This page lists the known errors on the gm5x5x5 PCBs. There are no known issues with the bulk order run (white PCBs), the following information is valid **only** for the prototype run (green PCBs).

Prototype Run

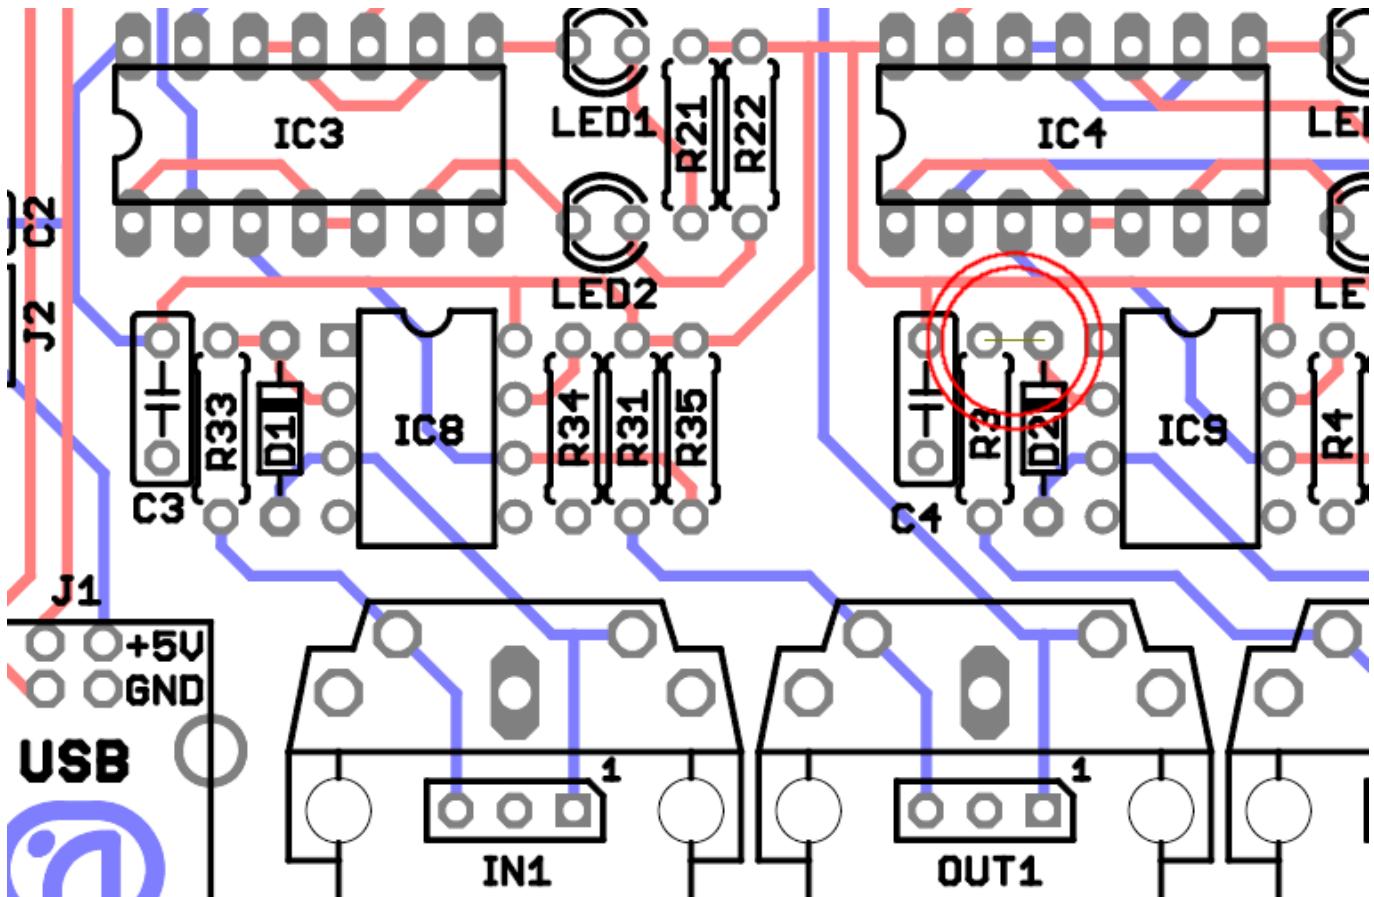
#1 MIDI IO pins

Problem: The MIDI IO pins of the midi sockets (Pin 4 + 5) are switched.

#2 MISSING TRACK

Problem: A track between D2 and R3 is missing.

Solution: Either (1) use the pin-headers if you use sockets that are not mounted on the PCB or (2) break the traces to pins 4 + 5 of the sockets and solder wires to them or (3) solder the MIDI sockets on the other side of the PCB.

Solution: Bridge the pins.
